# **Mount Piper to Wallerawang Transmission Line Upgrade Project**

Amendment Report

December 2025

**Figure 3.7b - Construction compounds and access tracks**

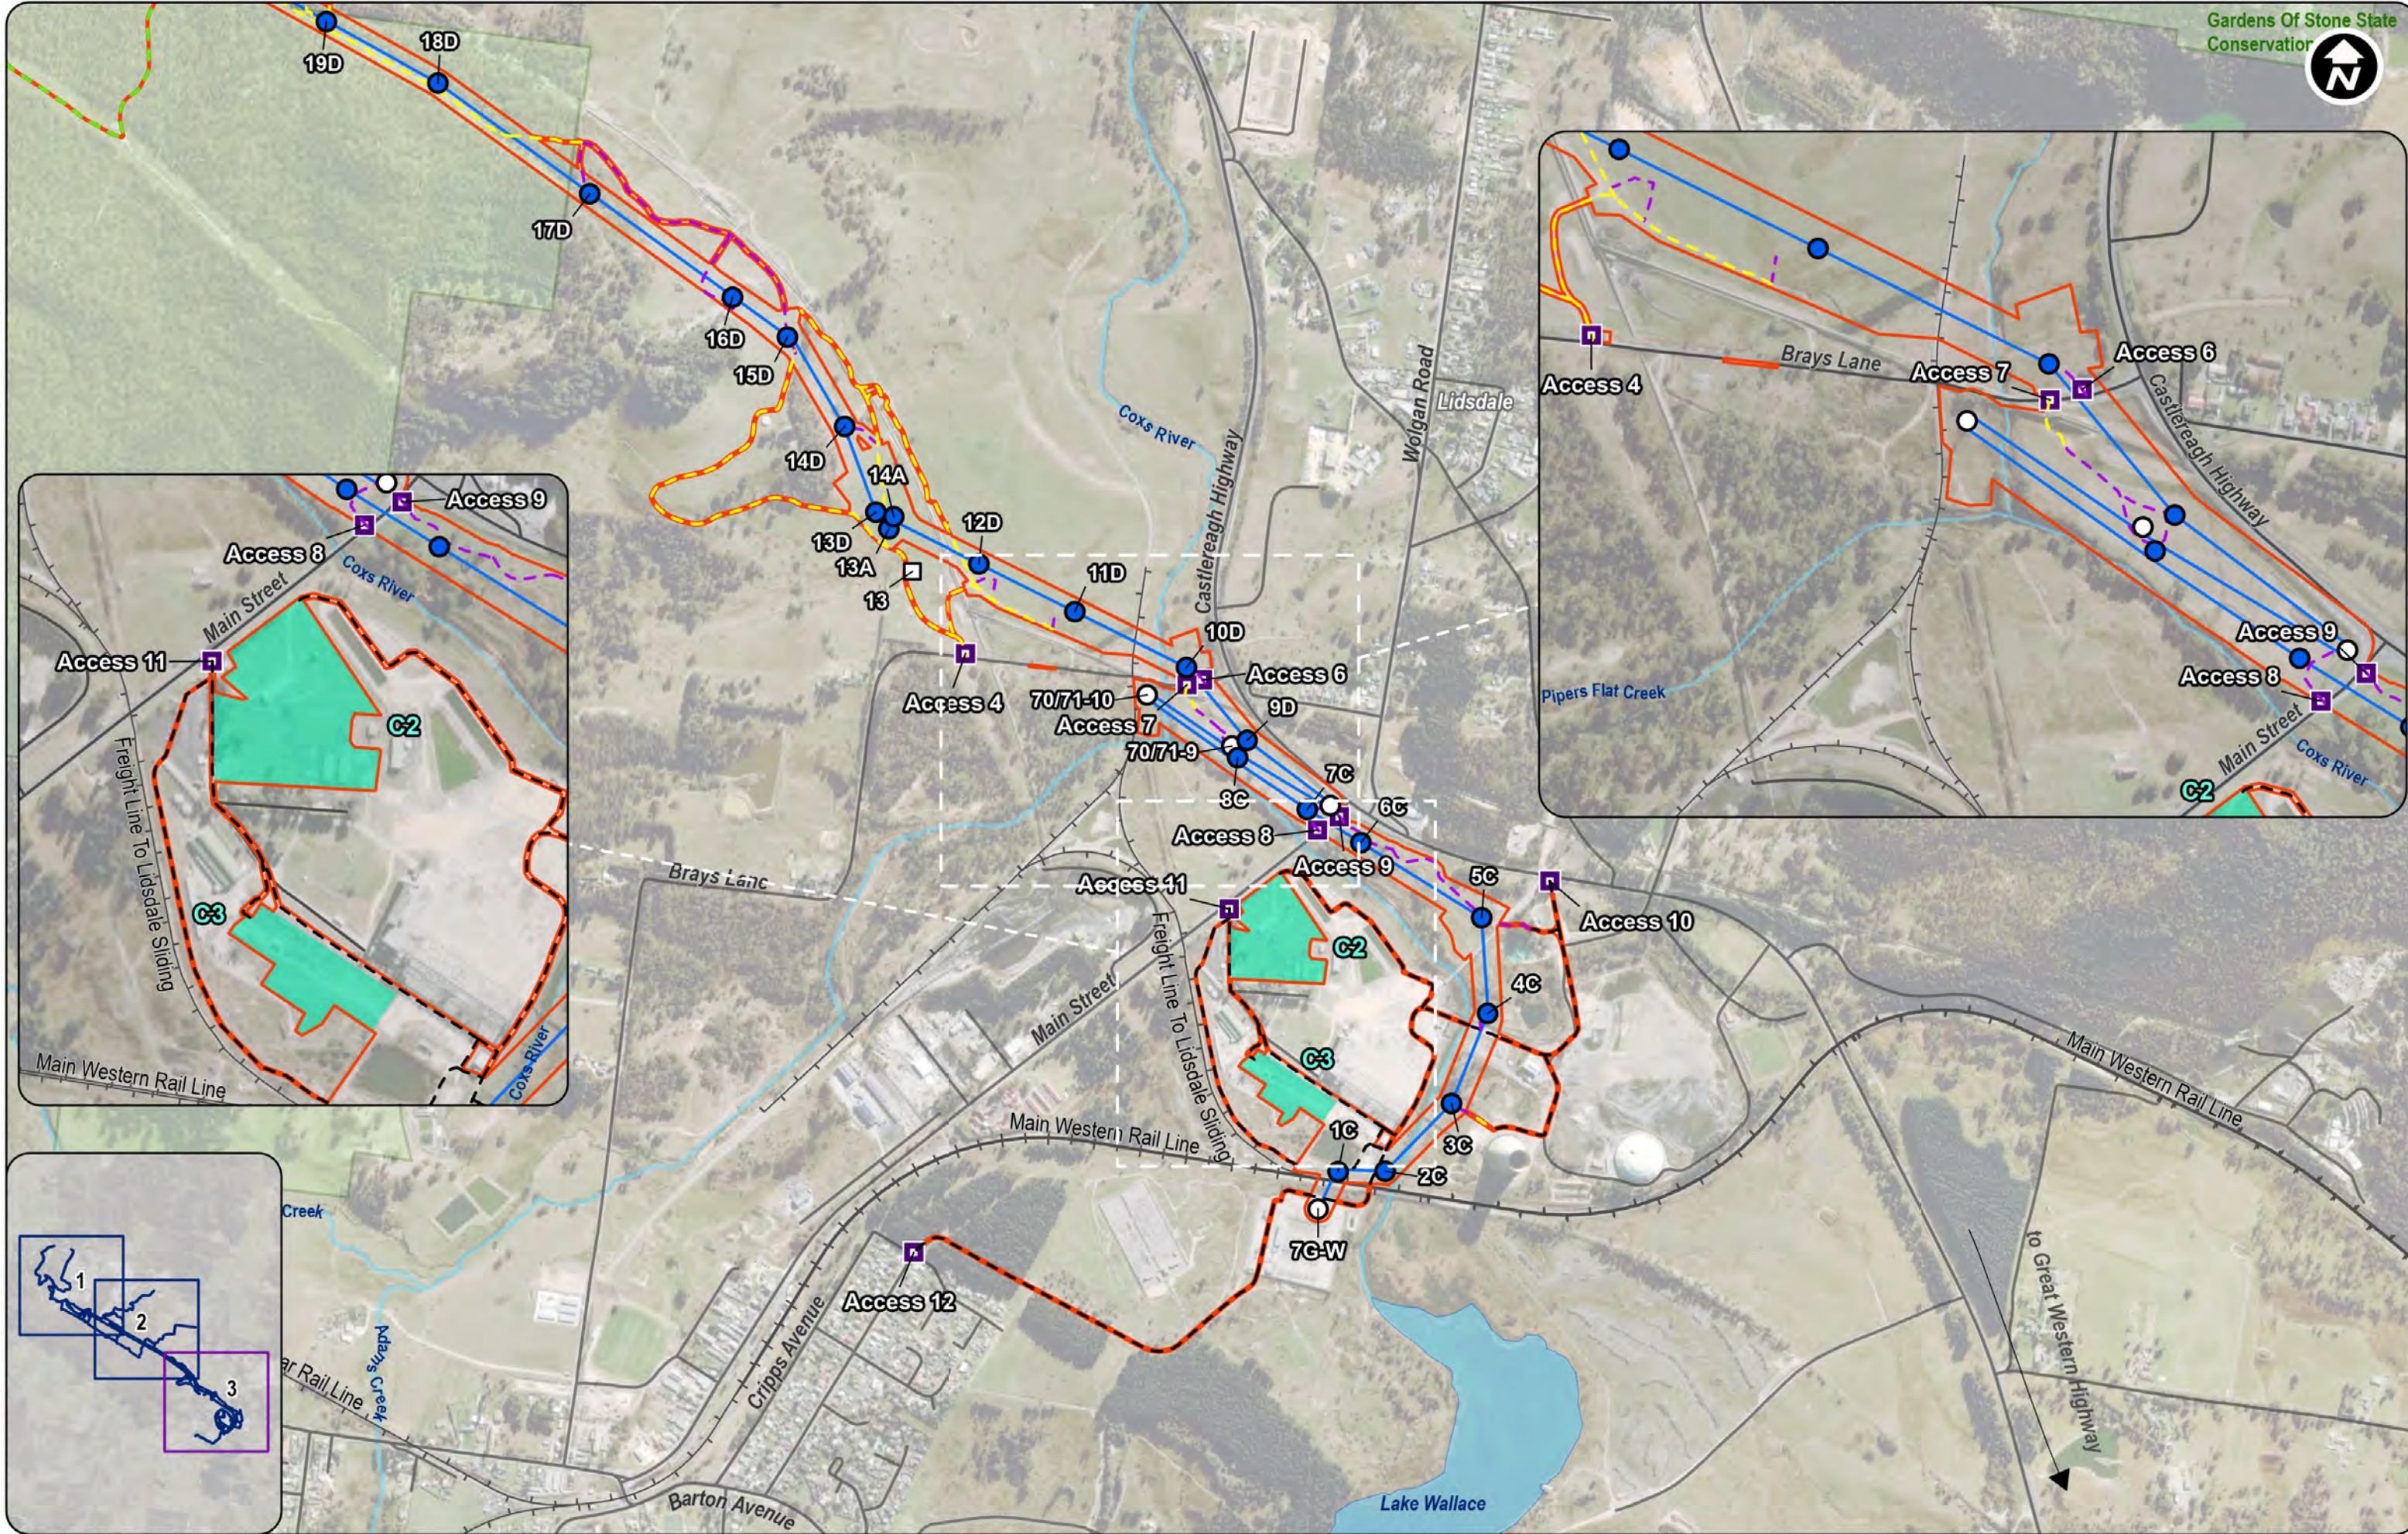
Of the total **1243** access points required for construction, ~~nine~~**eight** access points would be used for future operation and maintenance:

- Main access point **1** (~~4~~): Mount Piper Power Station entrance road off Boulder Road, Blackmans Flat
- Wallerawang access points **4, 6 and 7** (~~4~~) to (~~7~~): Brays Lane, Wallerawang
- Wallerawang access points **8 and 9** (~~8~~) and (~~9~~): Main Street, Wallerawang

- Wallerawang access point **10** ~~(10)~~: Castlereagh Highway, Wallerawang
- Wallerawang 330 kV substation access point **12** ~~(12)~~: Heel Street, Wallerawang.
